PASADENA WATER AND POWER

SUBJECT: National Aeronautics and Space Administration (NASA), Jet Propulsion Laboratory (JPL) Technical Memorandum (TM): Additional Investigation Results, January 31, 2007

Review and Comments of NASA's Jet Propulsion Laboratory 31-Jan-07 Technical Memorandum: Additional Investigation Results

REVIEW AND COMMENTS OF NASA'S 31-JAN-07 JET PROPULSION LABORATORY TECHNICAL MEMORANDUM: ADDITIONAL INVESTIGATION RESULTS

Figure 10

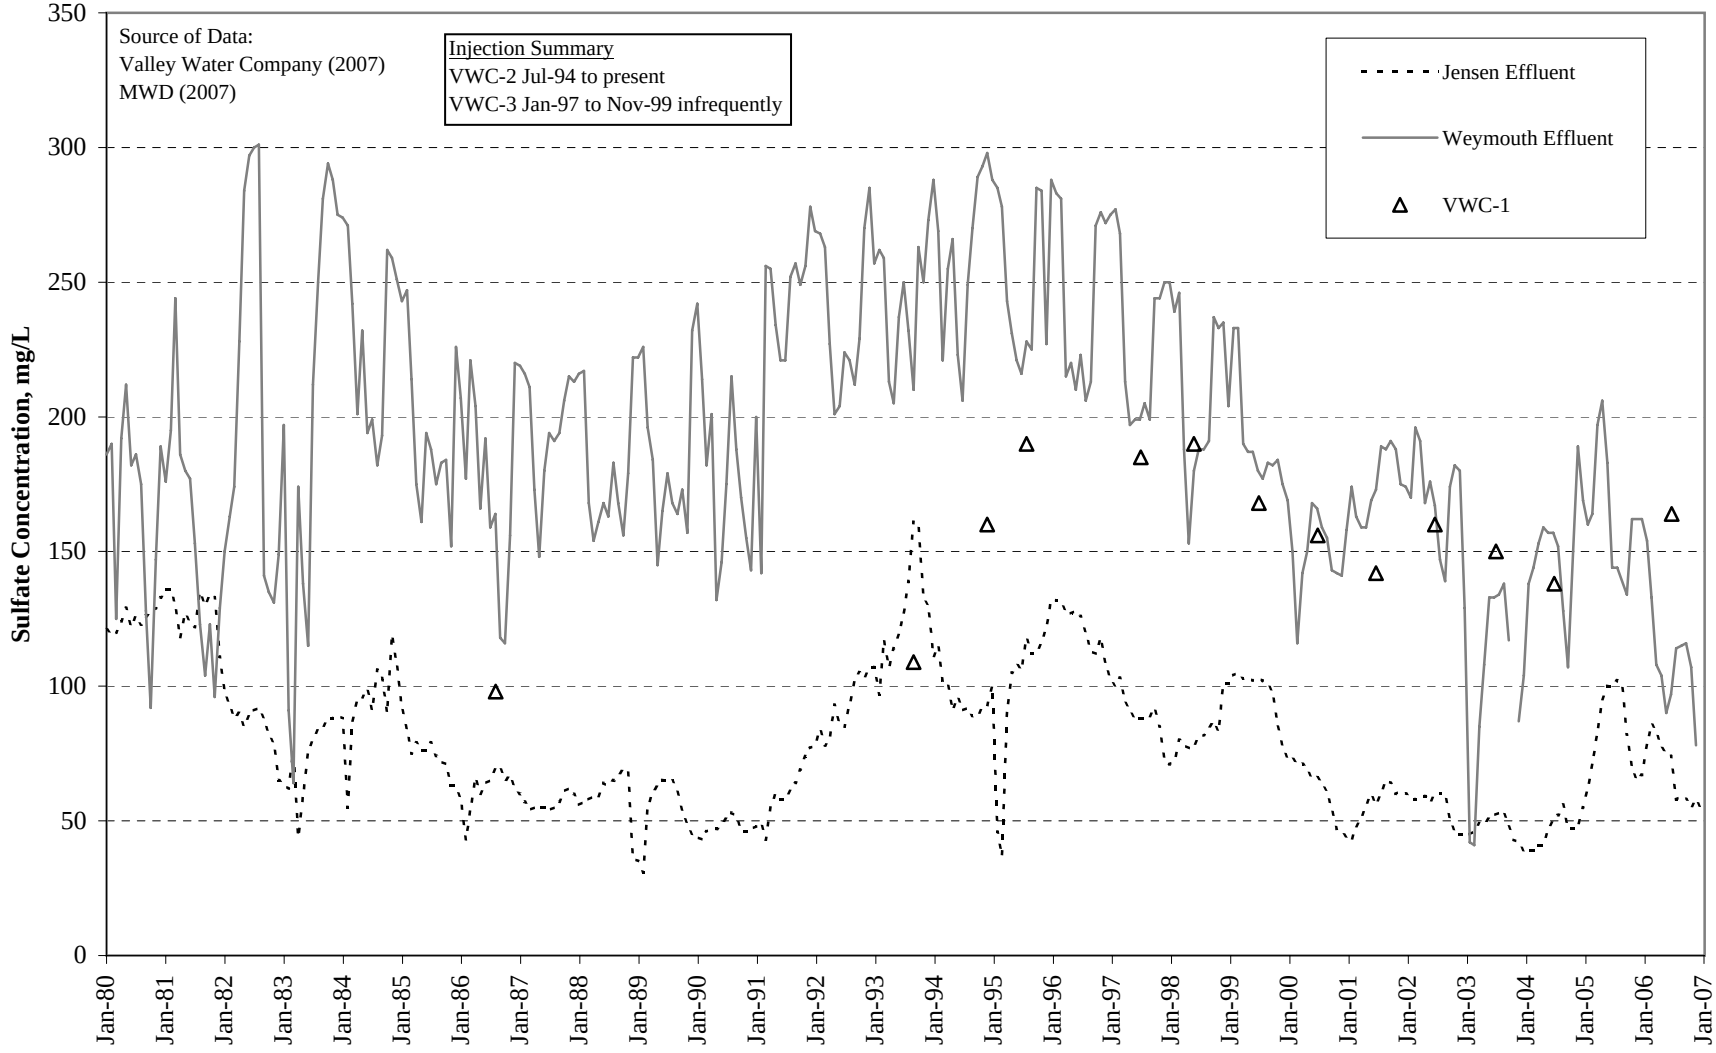
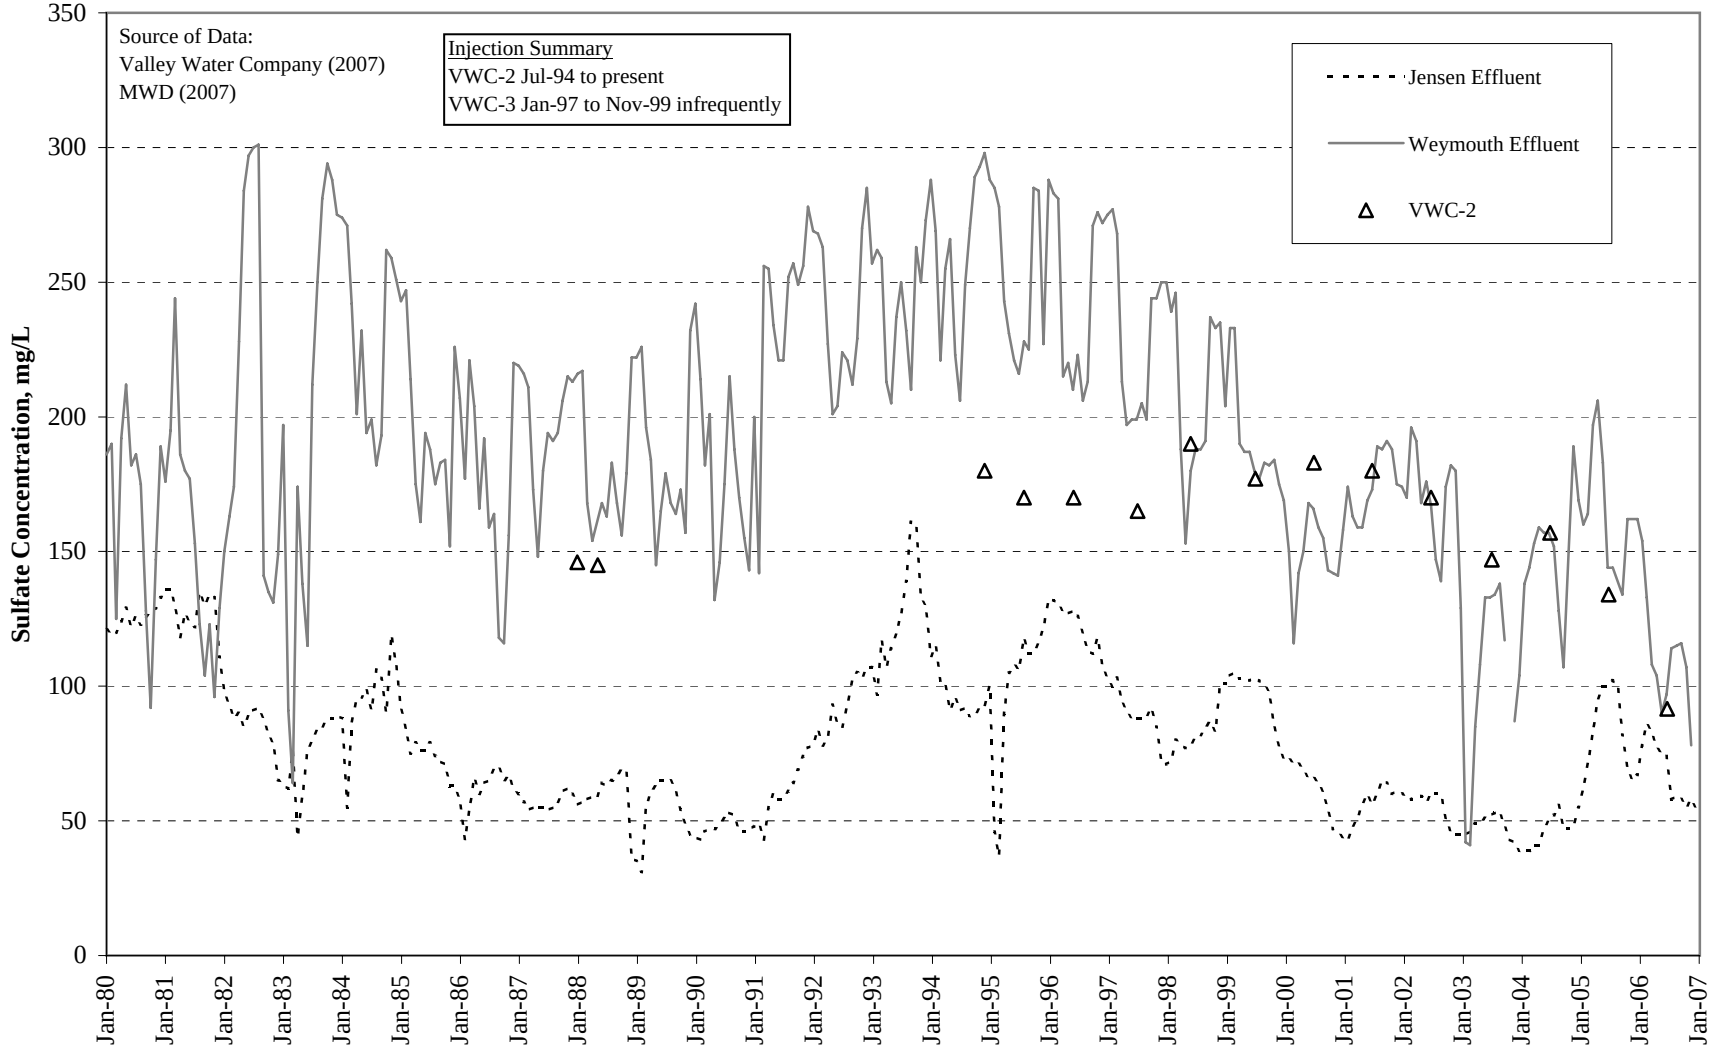
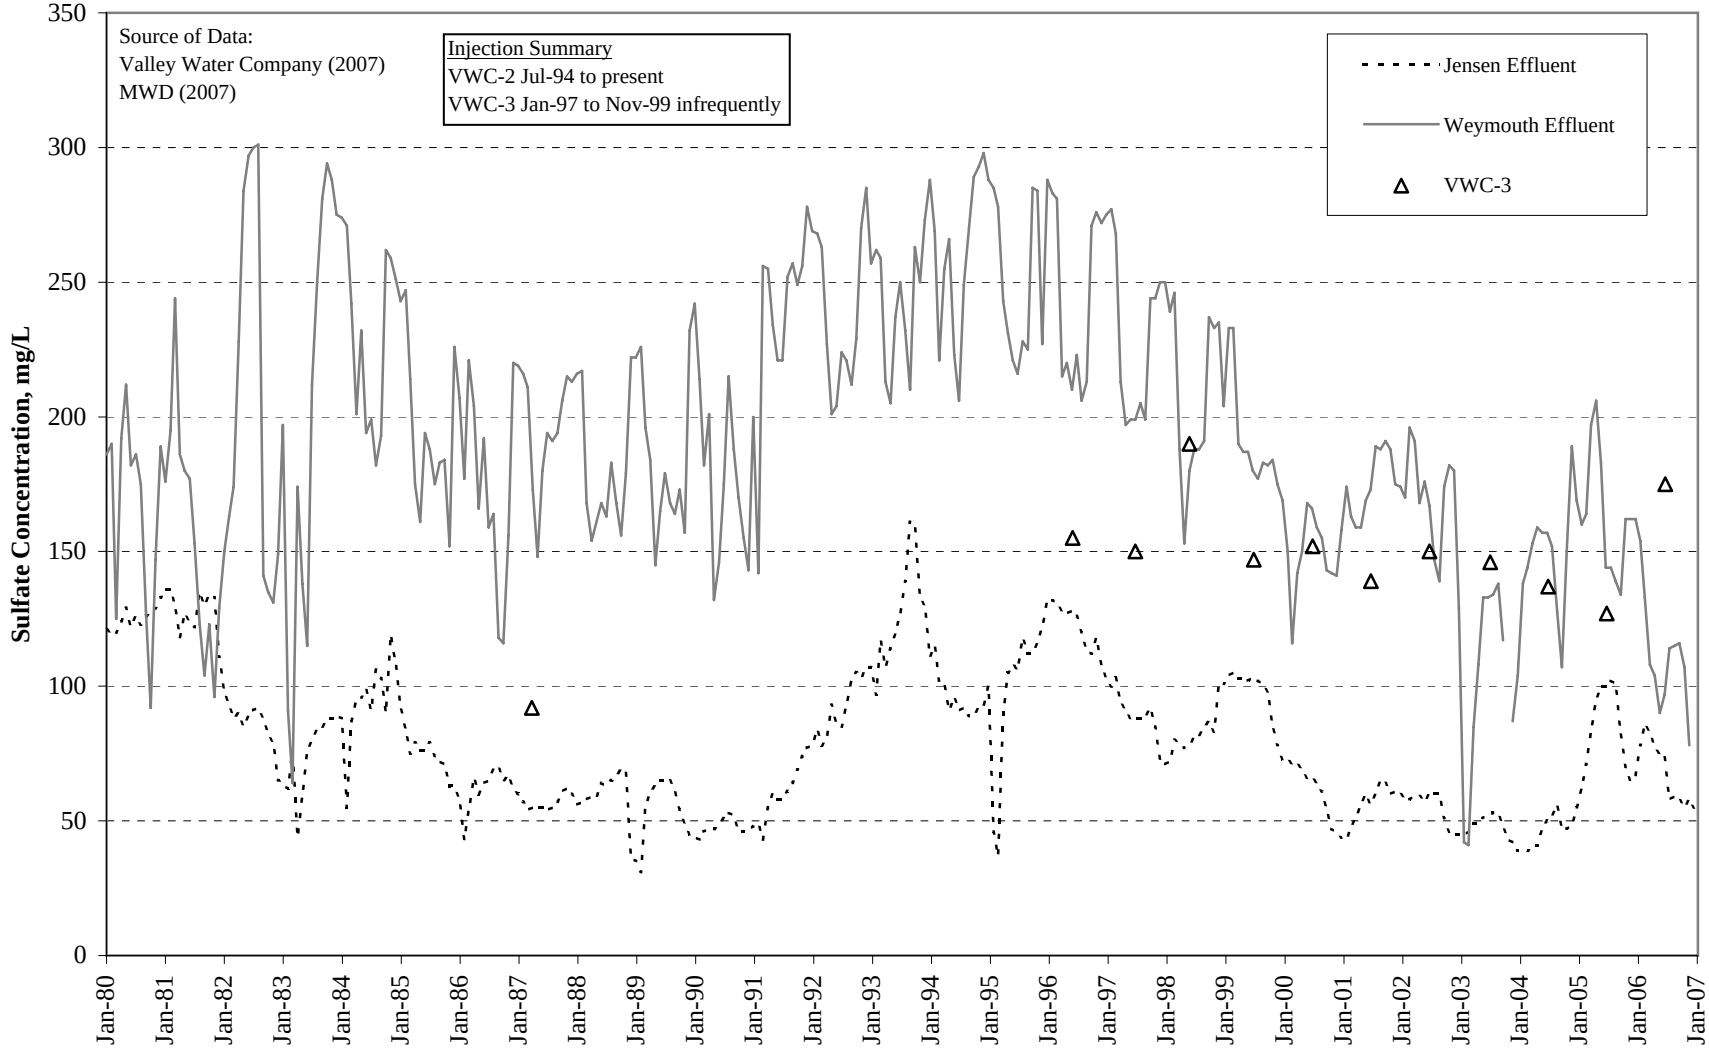
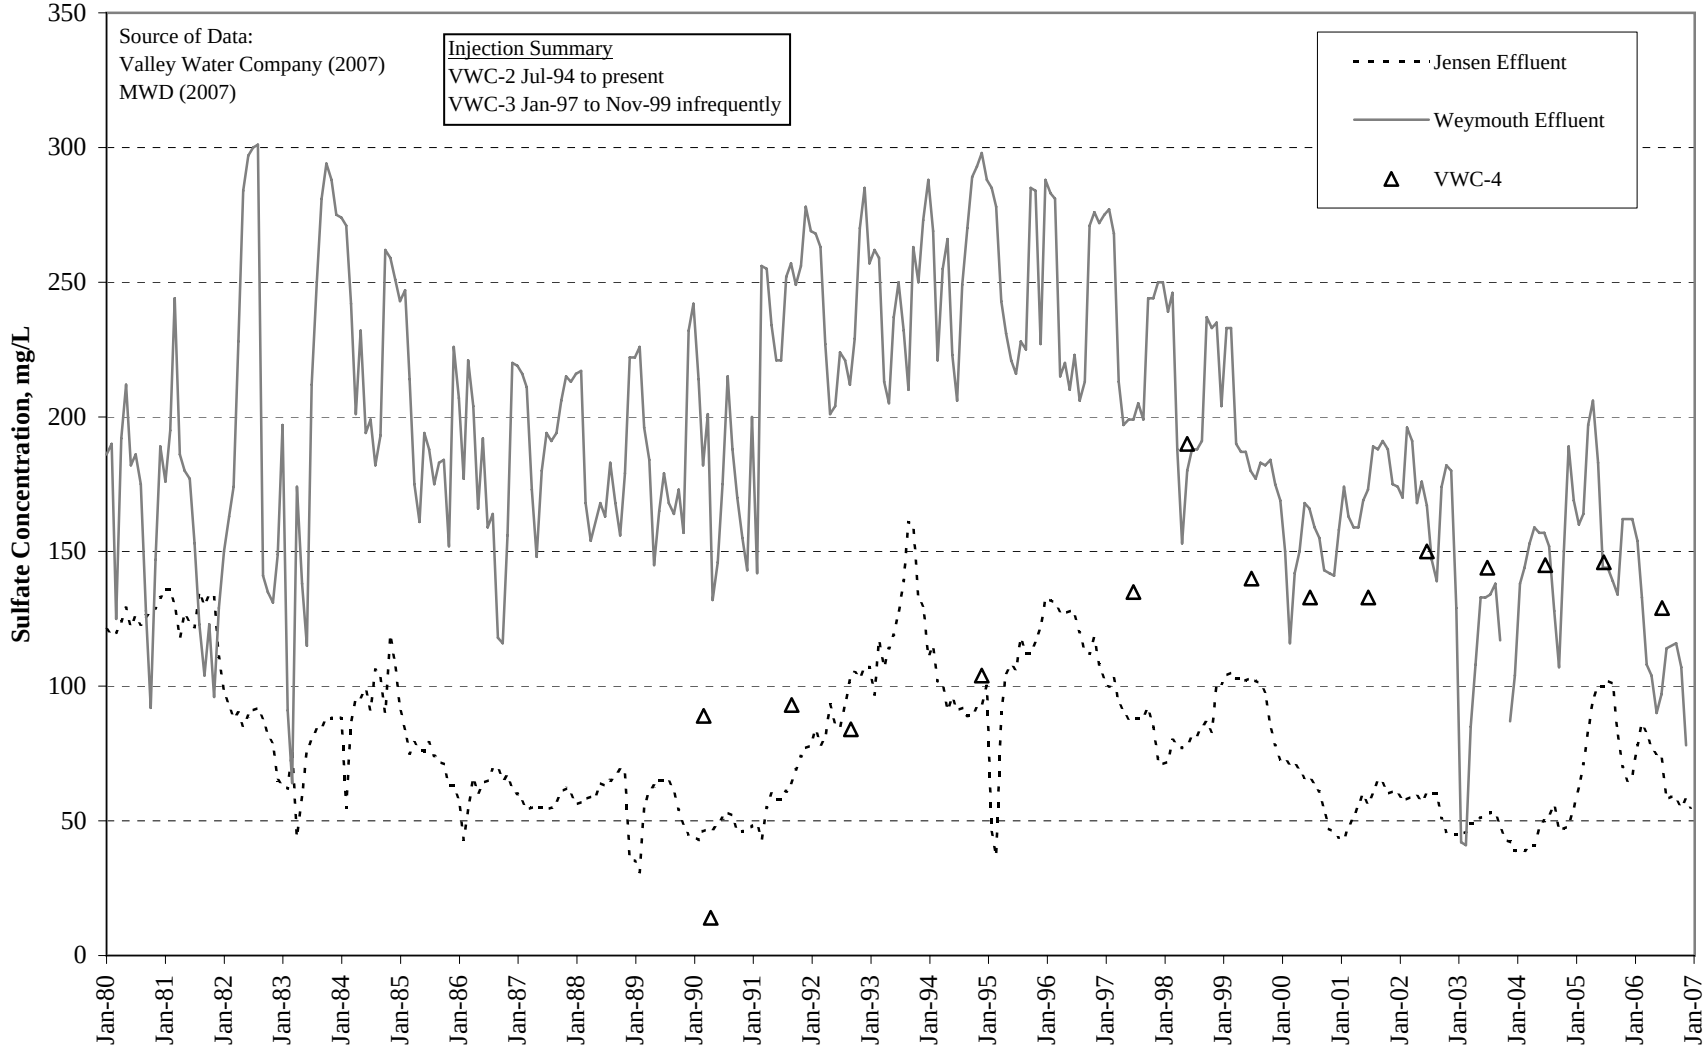
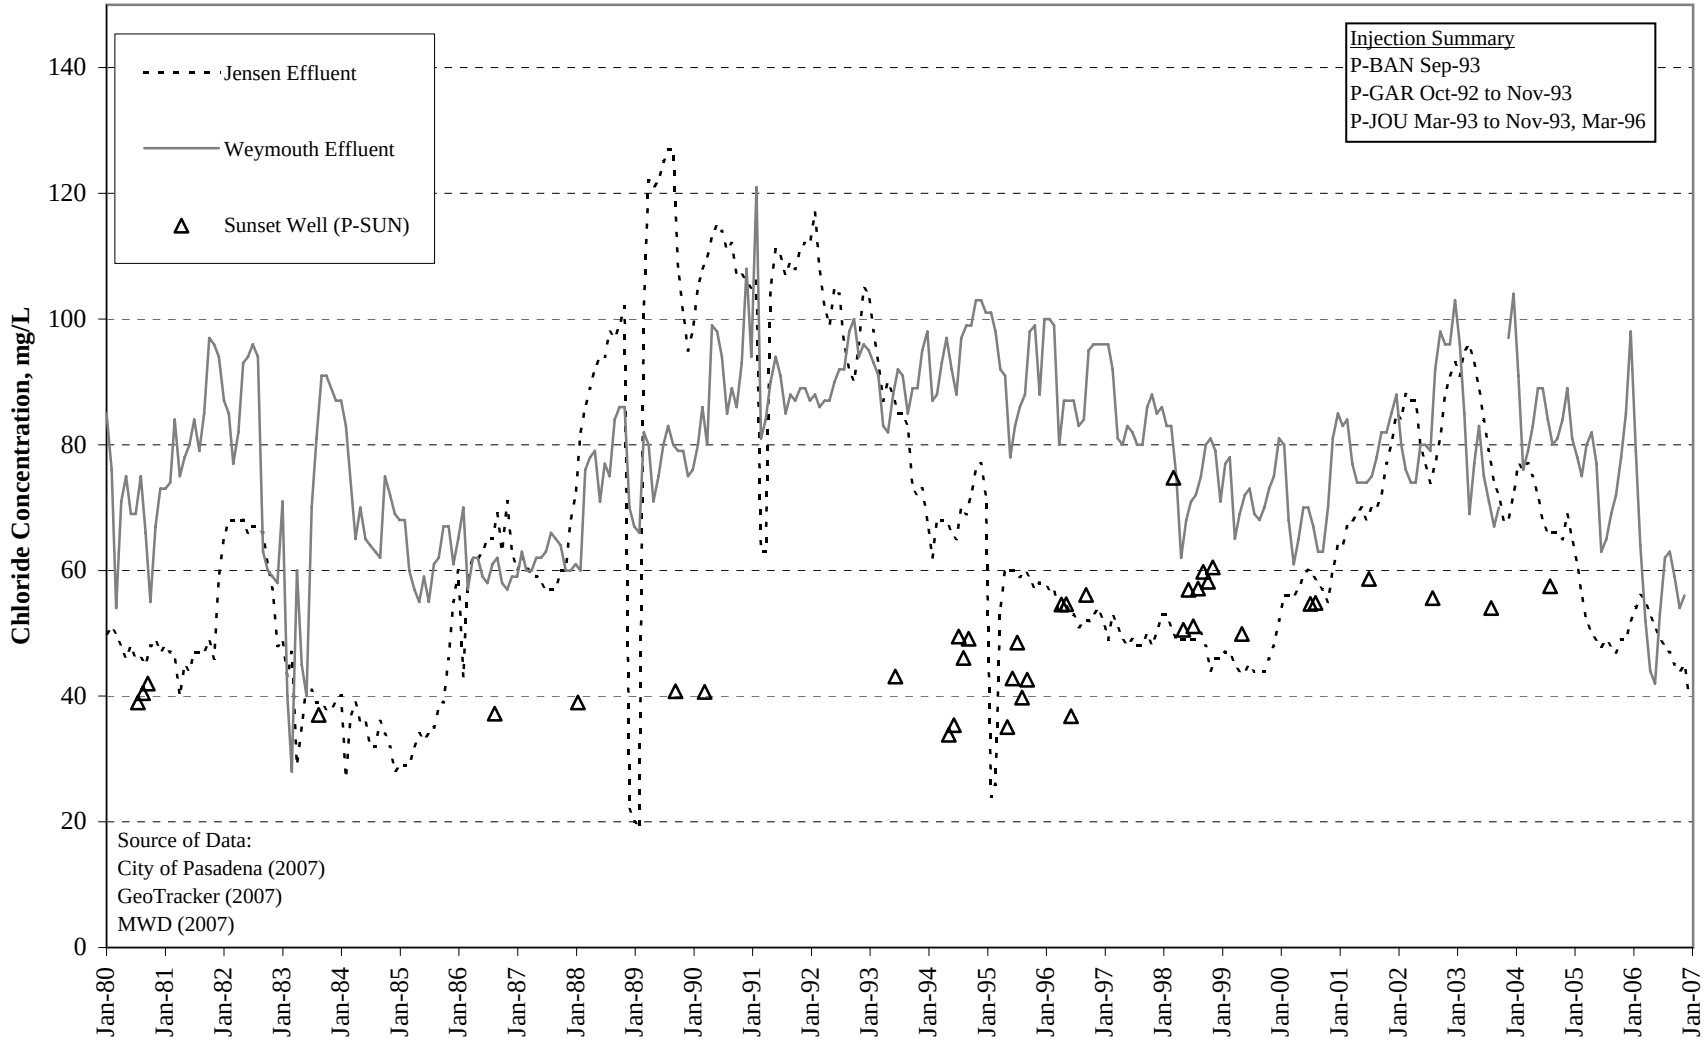
It is agreed that sulfate in the Basin has increased in some areas, possibly due to the importation of Colorado River Water and recharged as return flow including septic tank discharge in unsewered areas. Also, in the Sunset Reservoir and Valley Water Company wells, historical sulfate trends show a range of increases, no changes and decreases as shown in Figures 5 – 31, and summarized in Table 1.

If the mechanism described by NASA for concentrating perchlorate in the ground water to levels above the source/recharge water was valid, it would be expected that other salts, such as sulfate, chloride and TDS would also increase in the ground water to concentrations exceeding the recharge water. Figures 5 through 13 show that sulfate in ground water (both Sunset Reservoir area and Valley Water Company wells) have mostly remained at or below imported Colorado River and State Project water concentrations, while Figures 32 through 36 show perchlorate in ground water significantly higher than concentrations in imported water for wells hydraulically downgradient of the JPL facility.
